FISHERS CANYON CREEK CHANNEL IMPROVEMENT PLANS

FISHERS CANYON APARTMENTS IS A MULTI-FAMILY RESIDENTIAL DEVELOPMENT THAT PROPOSES 336 DWELLING UNITS ALONG THE FISHERS CANYON CREEK CORRIDOR. THE PROJECT EMBRACES FISHERS CANYON CREEK TRIBUTARY TO THE WEST AND FISHERS CANYON CREEK TO THE NORTH WITH CREEK IMPROVEMENTS. COUNTY PROJECT NUMBER #CDR246.

FISHERS CANYON CREEK
CHANNEL IMPROVEMENT PLANS
EL PASO COUNTY, COLORADO
COVER

TRIBUTARY - PLAN VIEW
STA. 61+05 TO 58+00

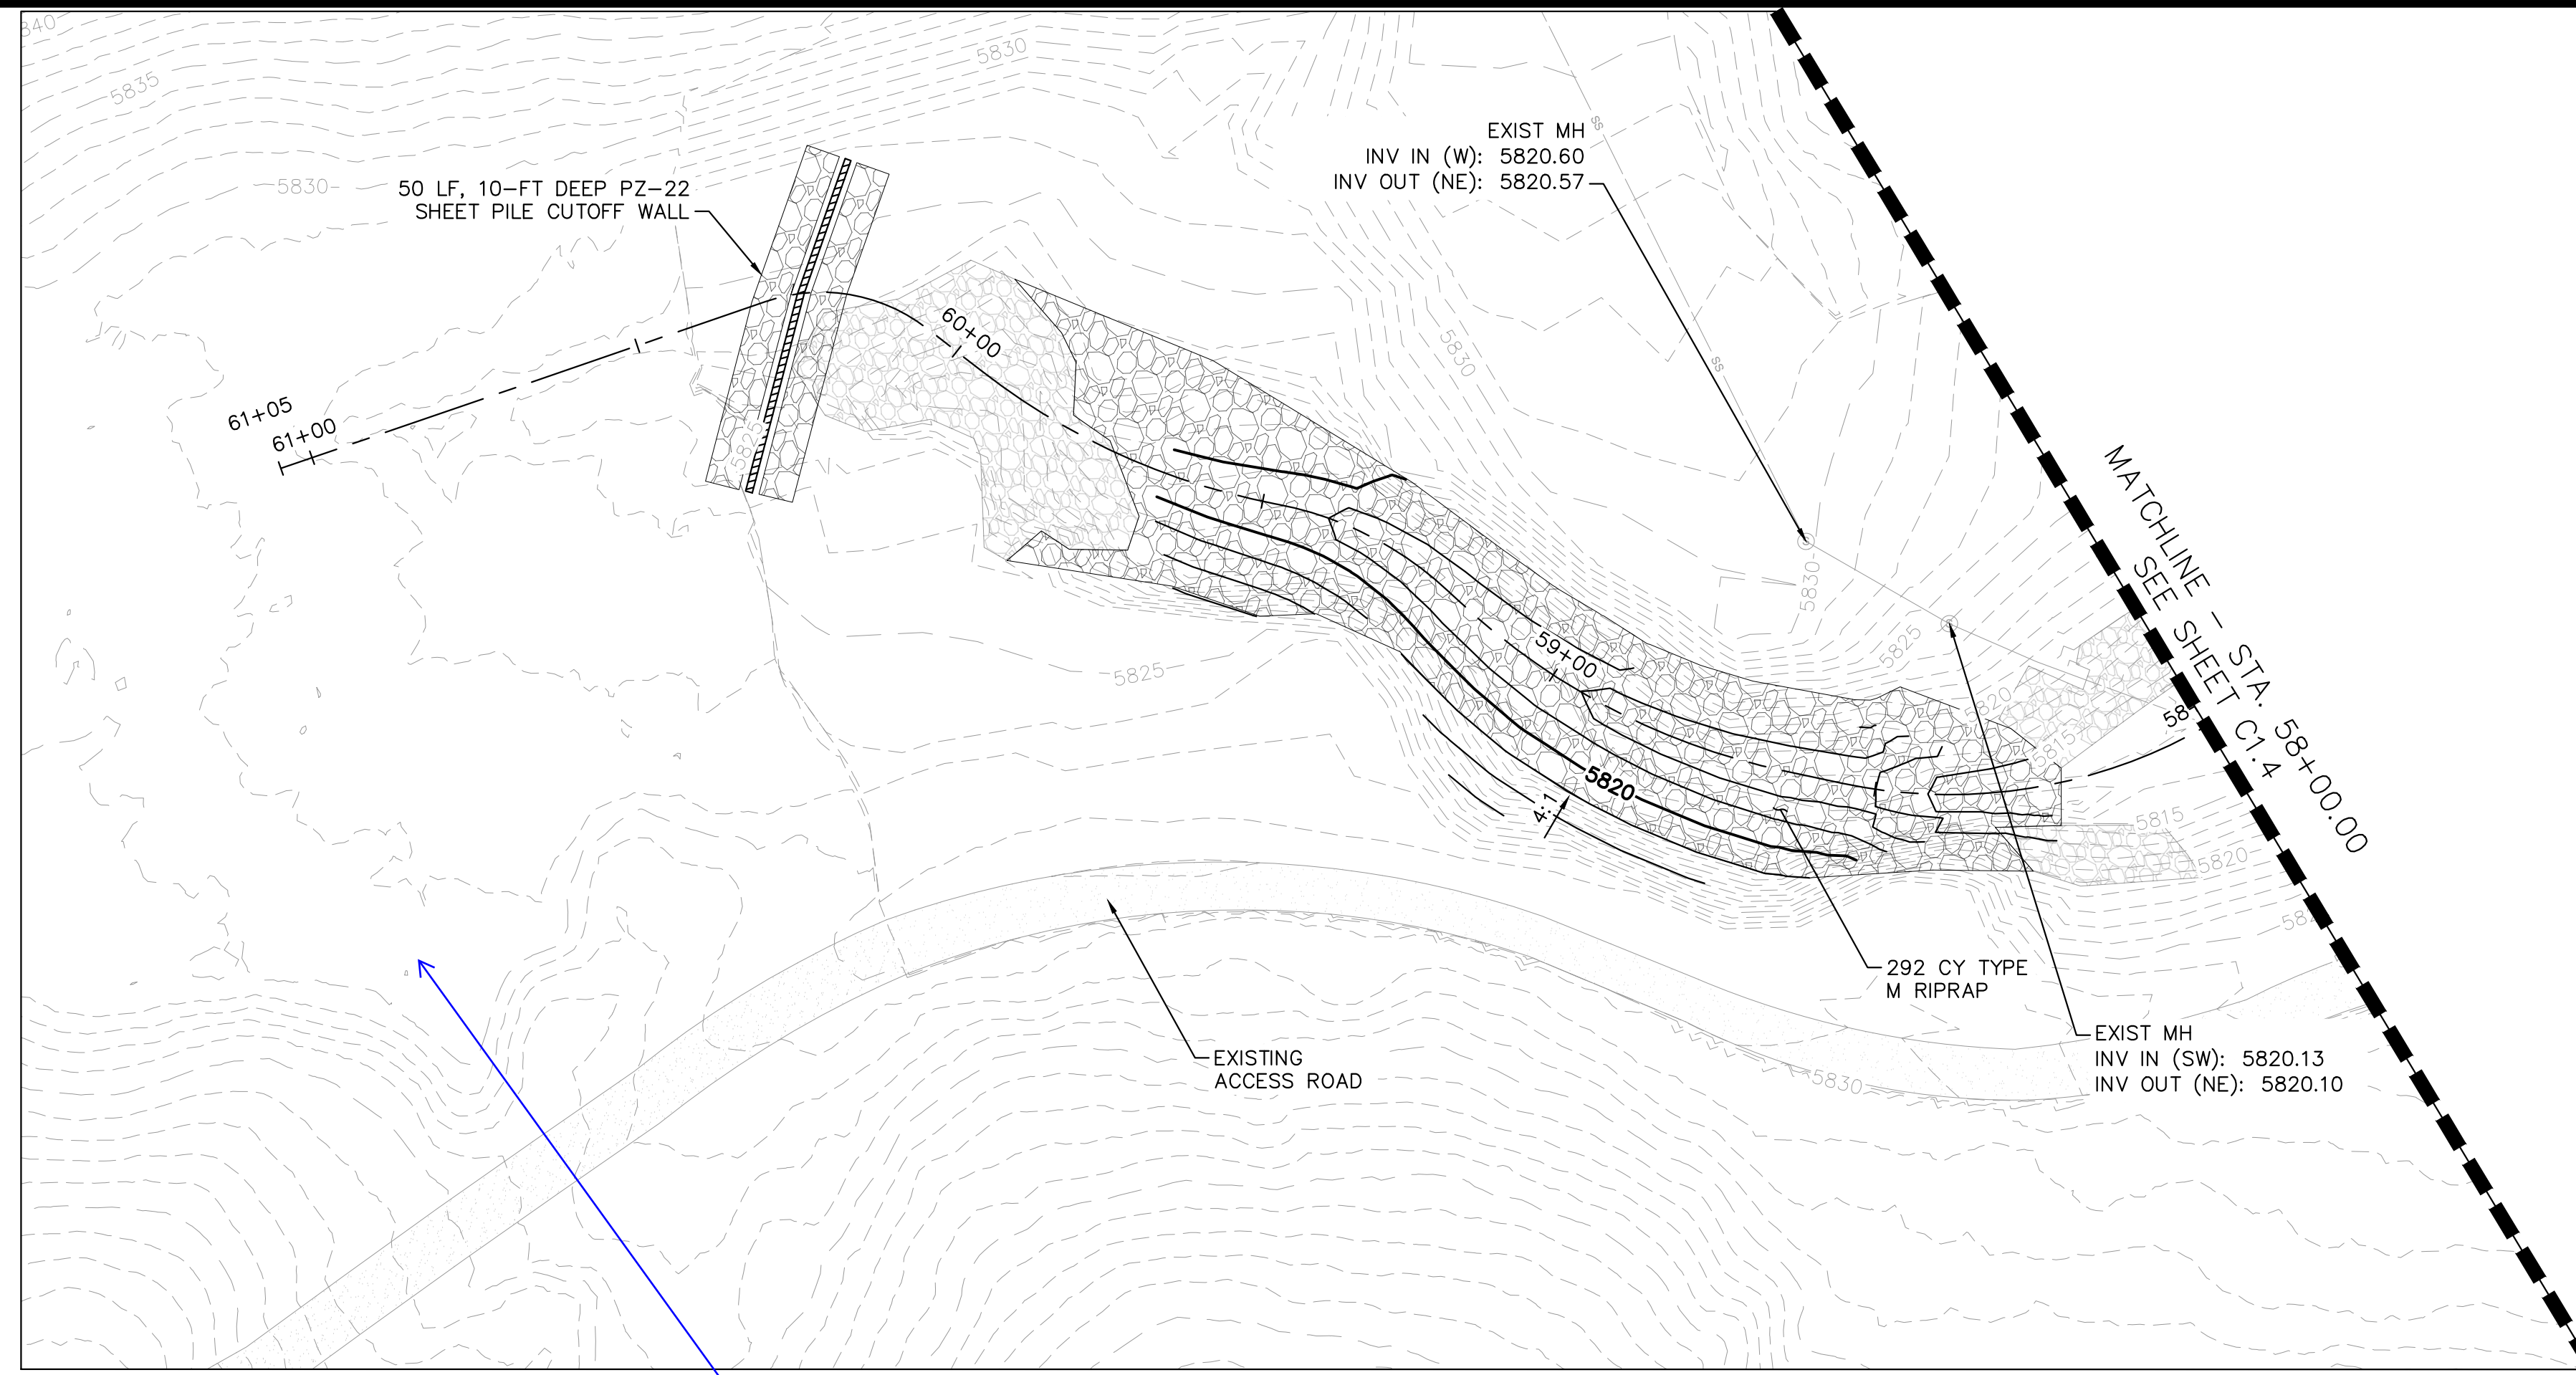
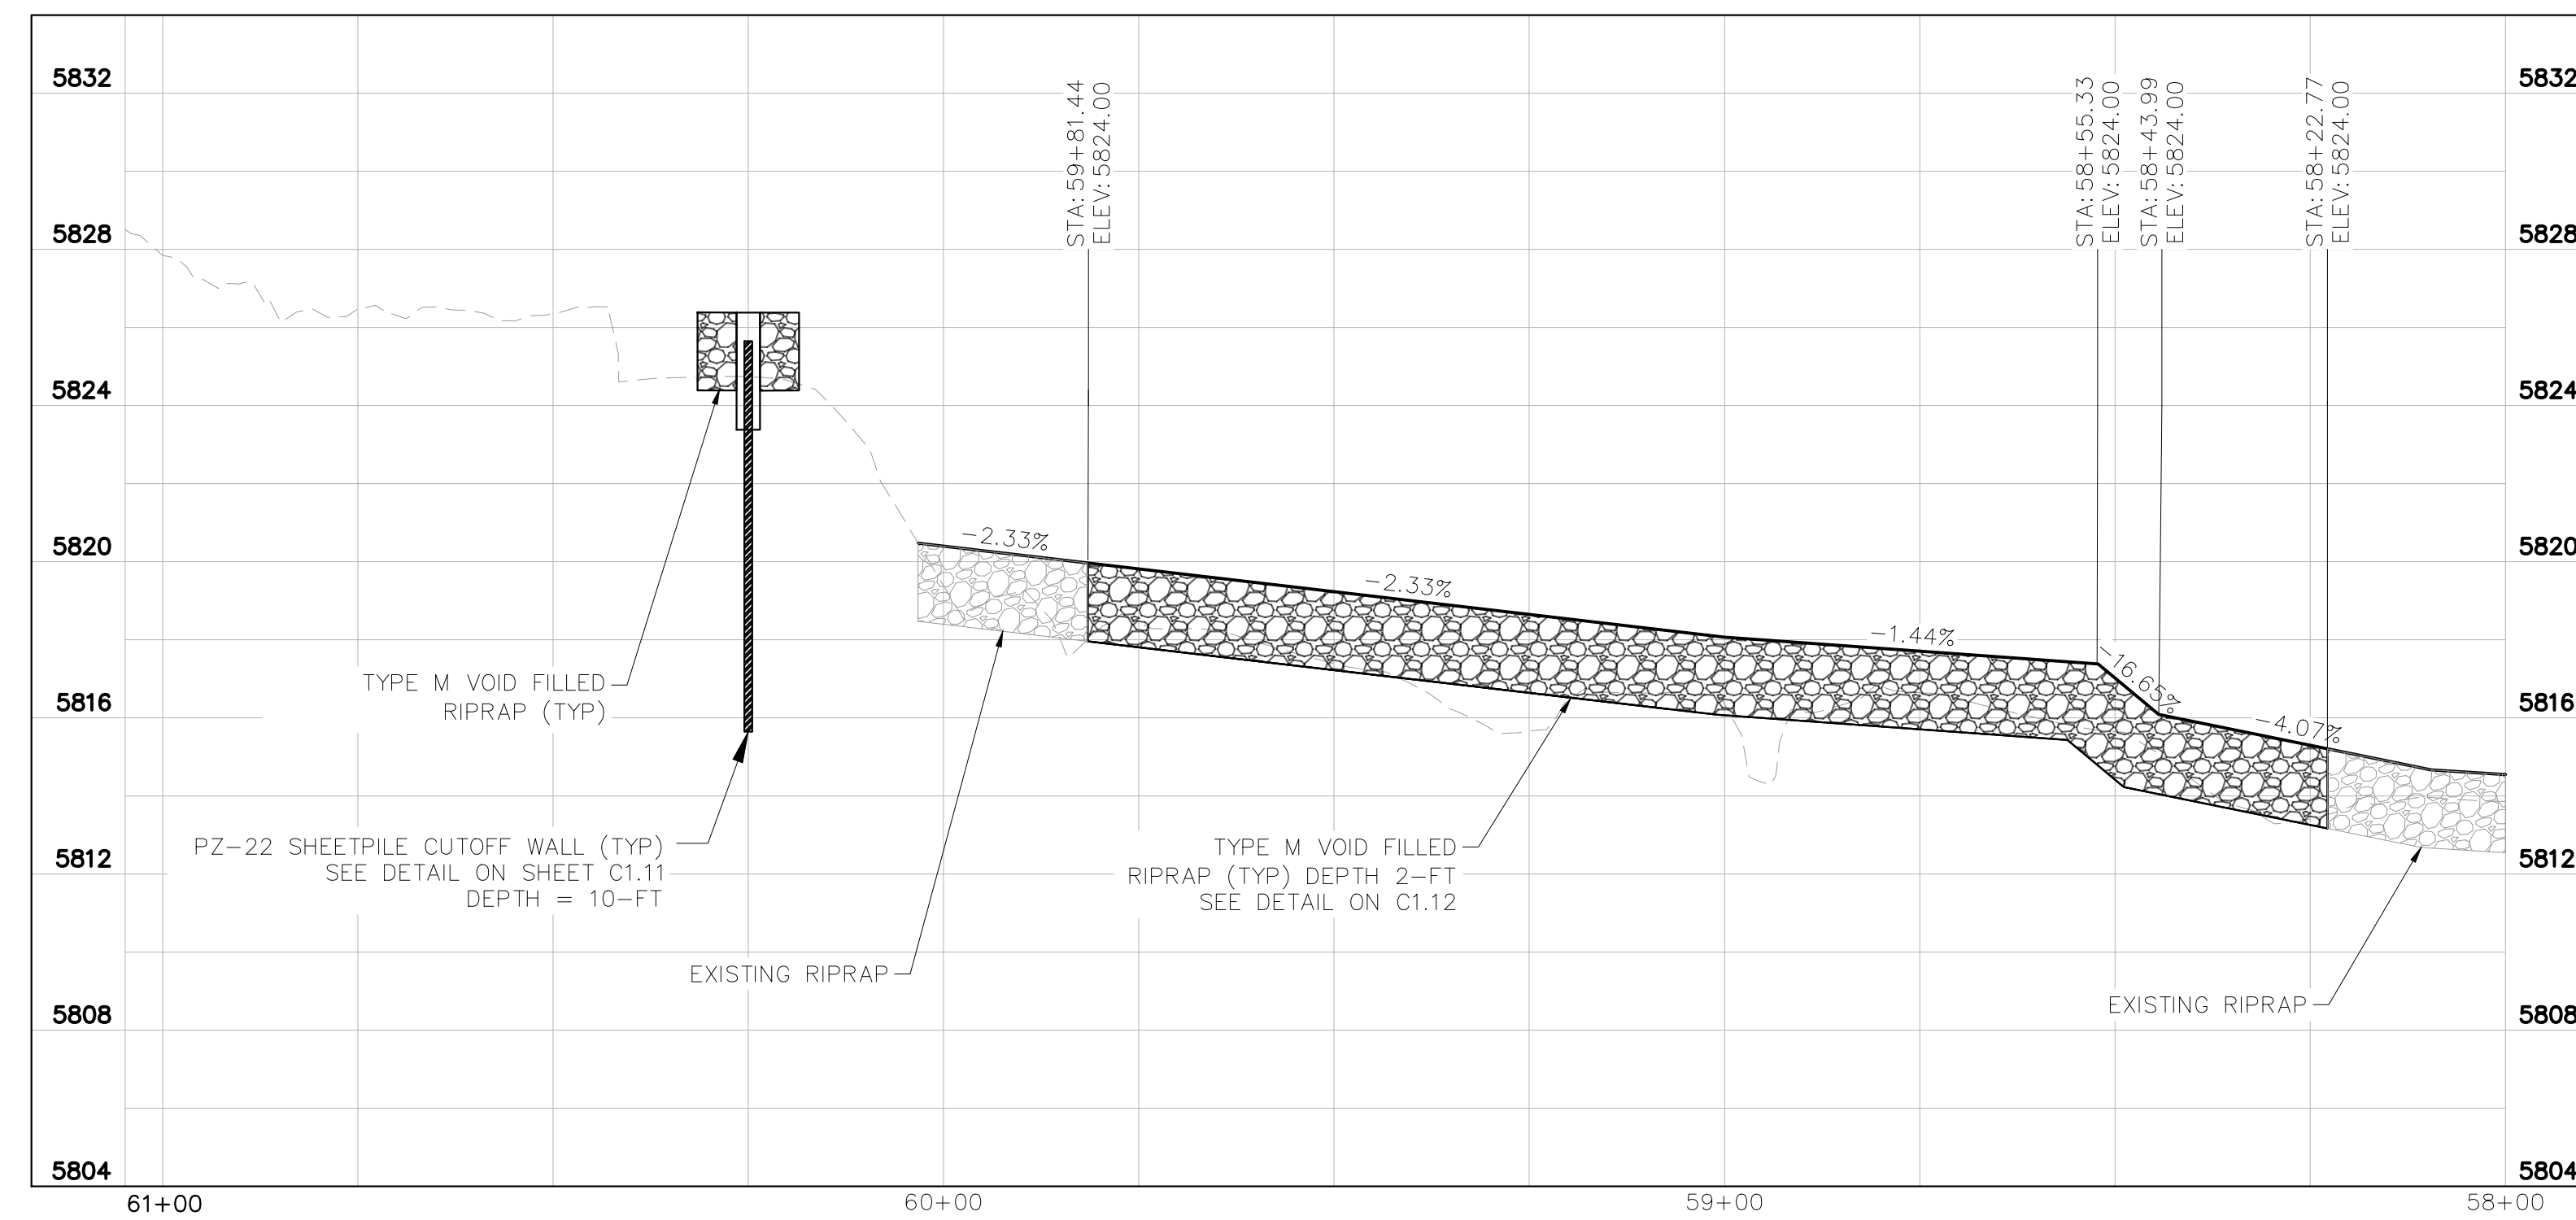
show the pond outfall

FISHERS CANYON CREEK
 GRADING AND EROSION CONTROL PLANS
 EL PASO COUNTY, COLORADO
INITIAL GEC PLAN

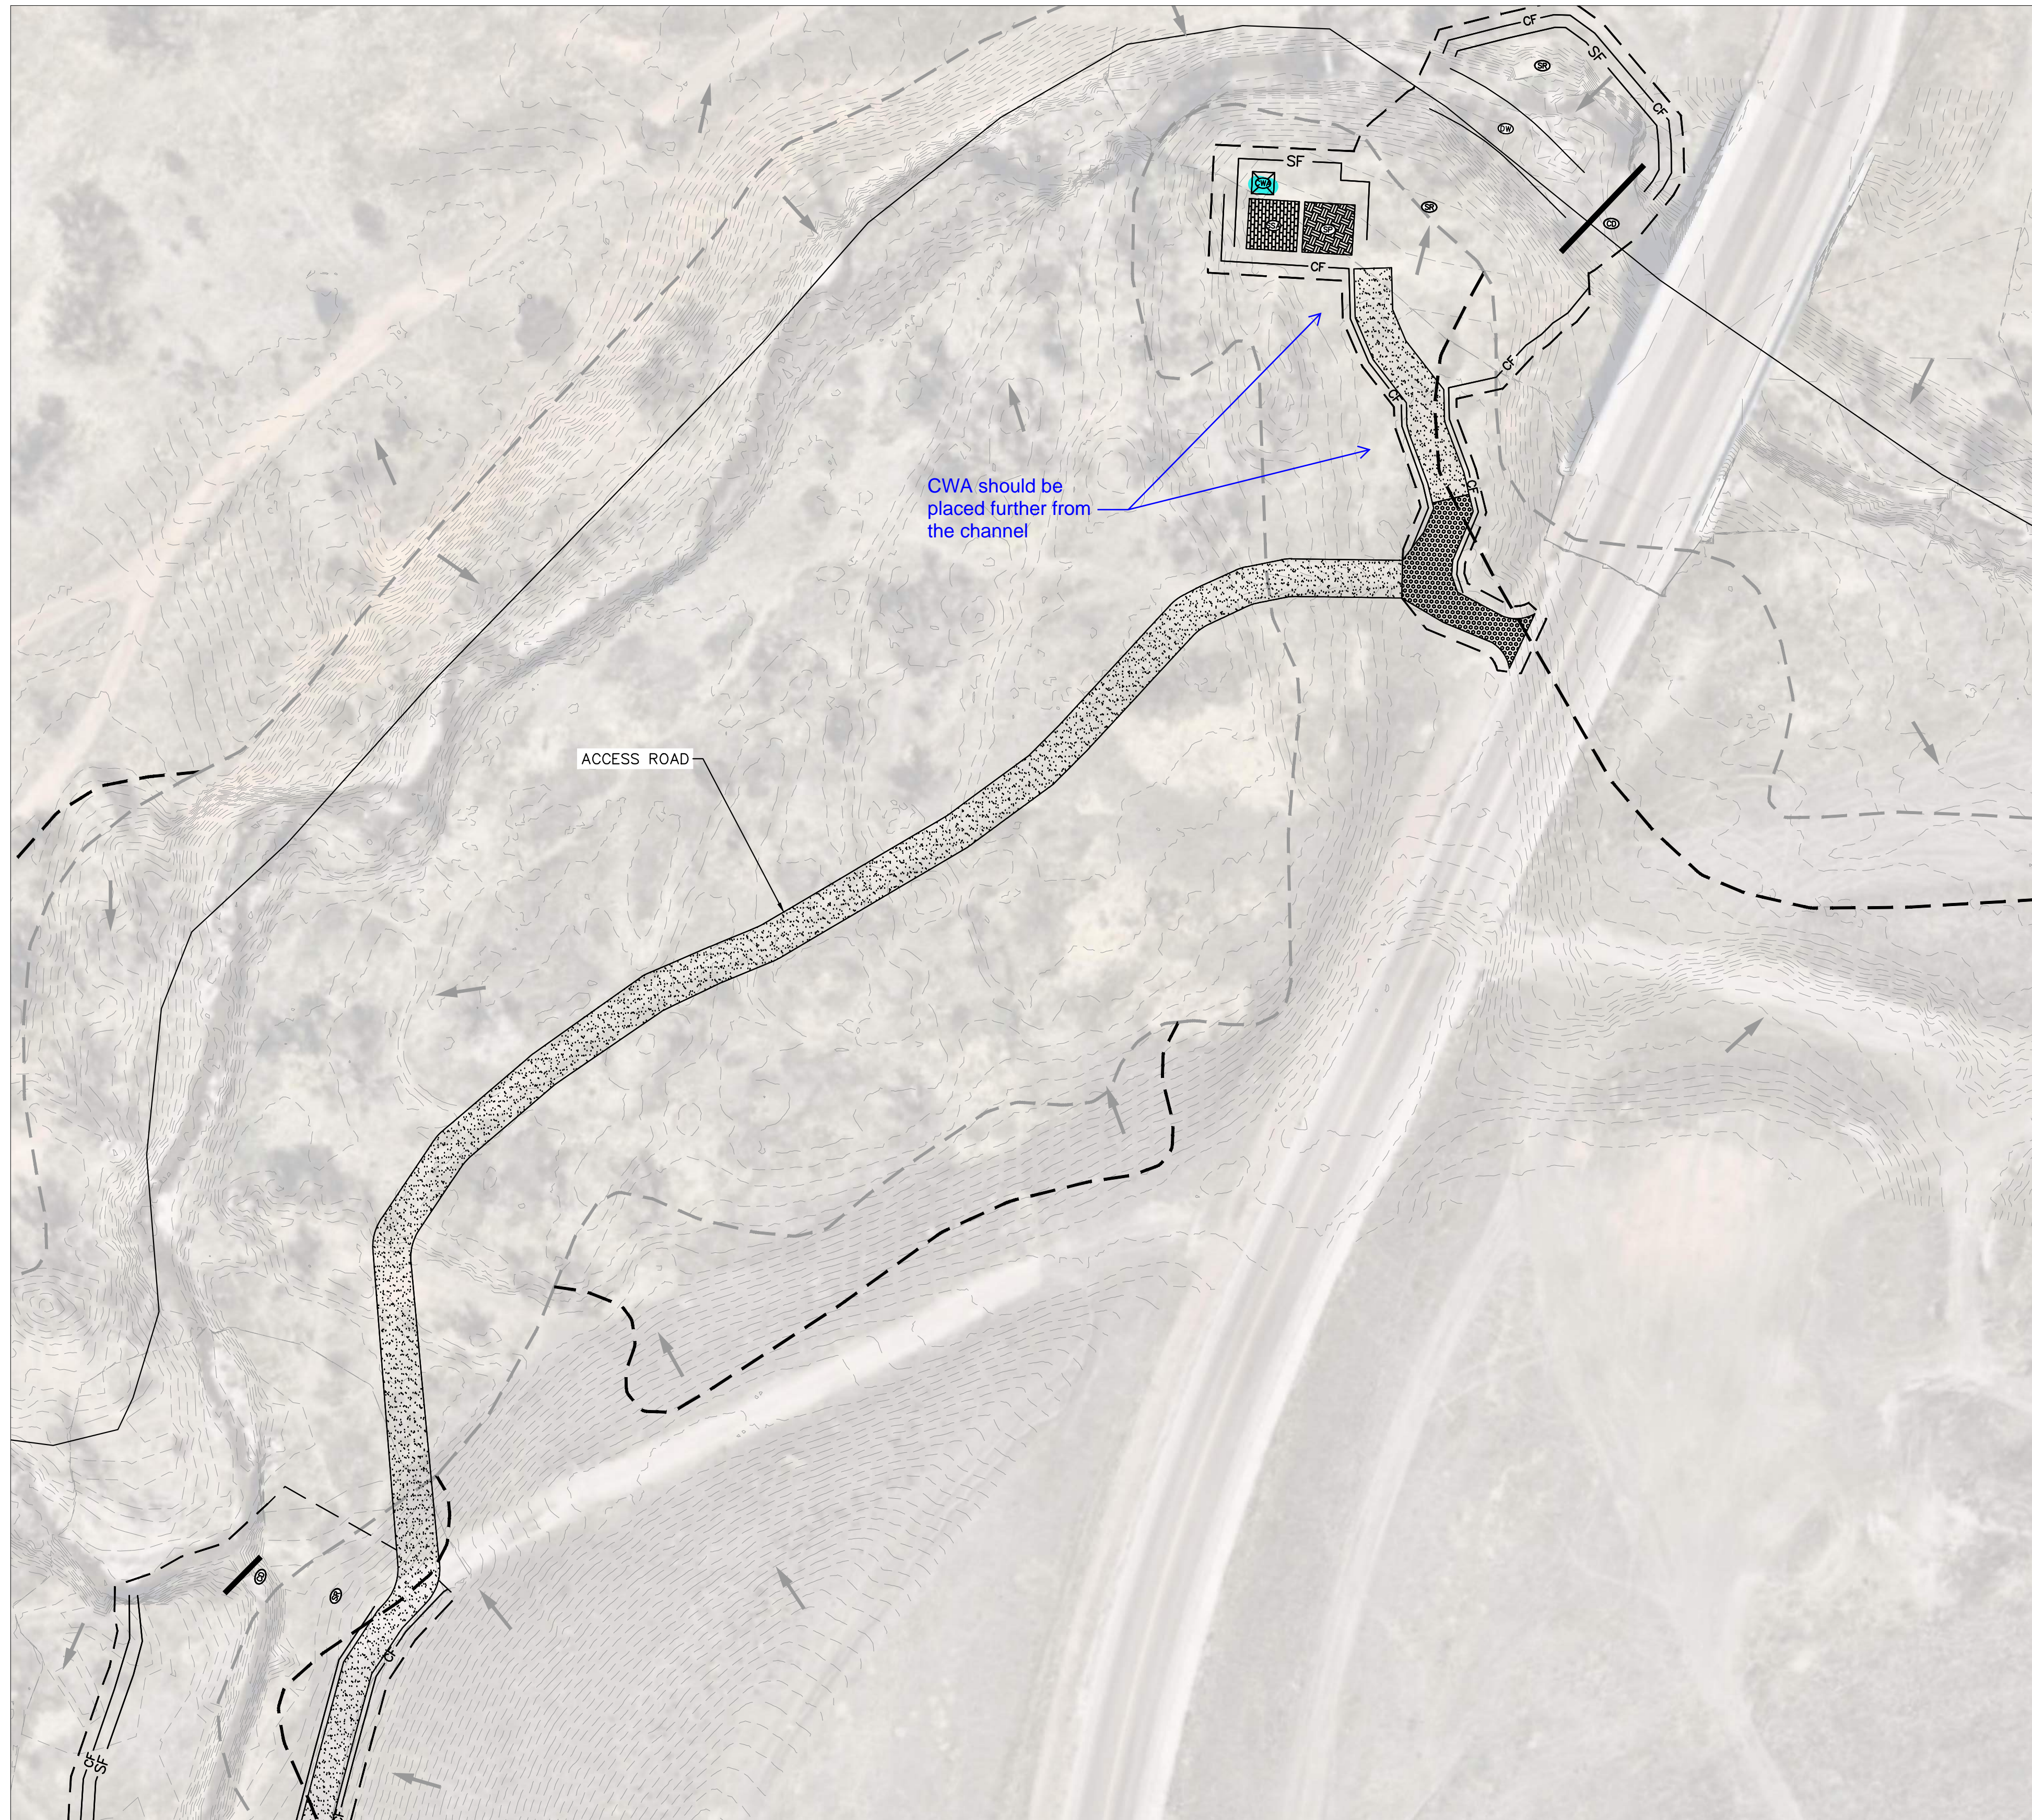
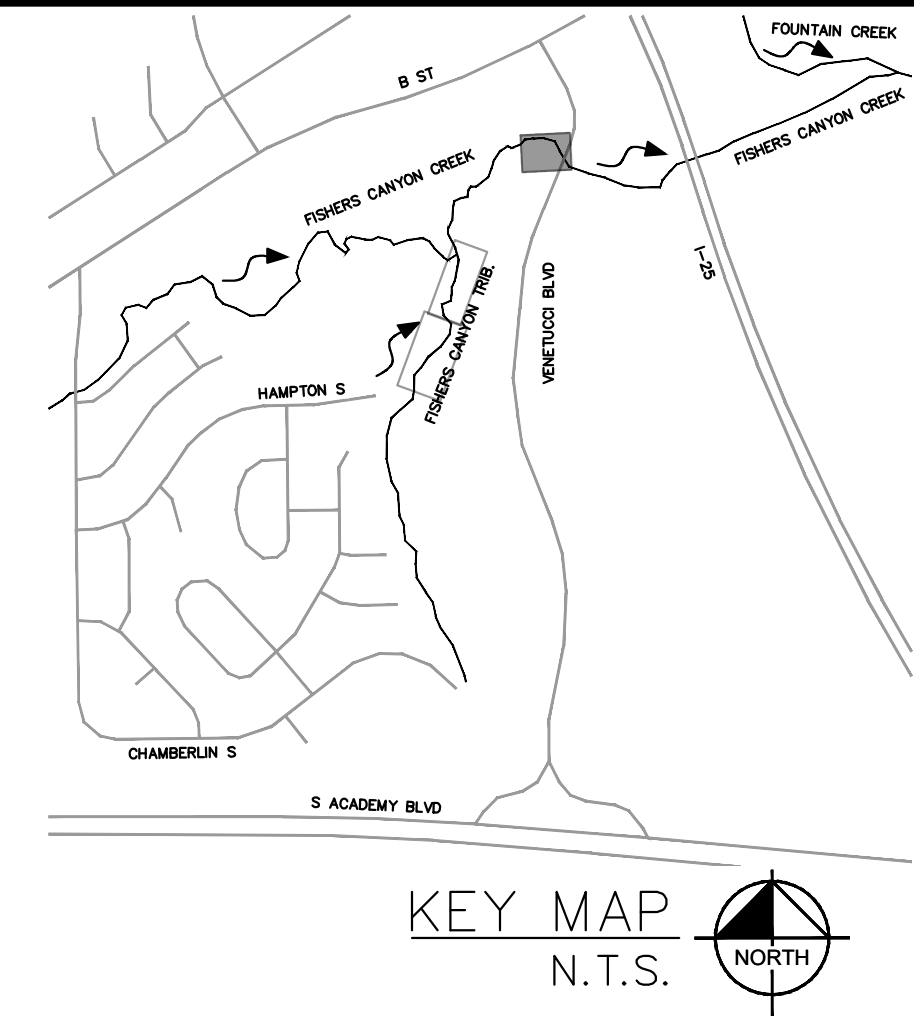
Add DW to legend

please submit GEC checklist
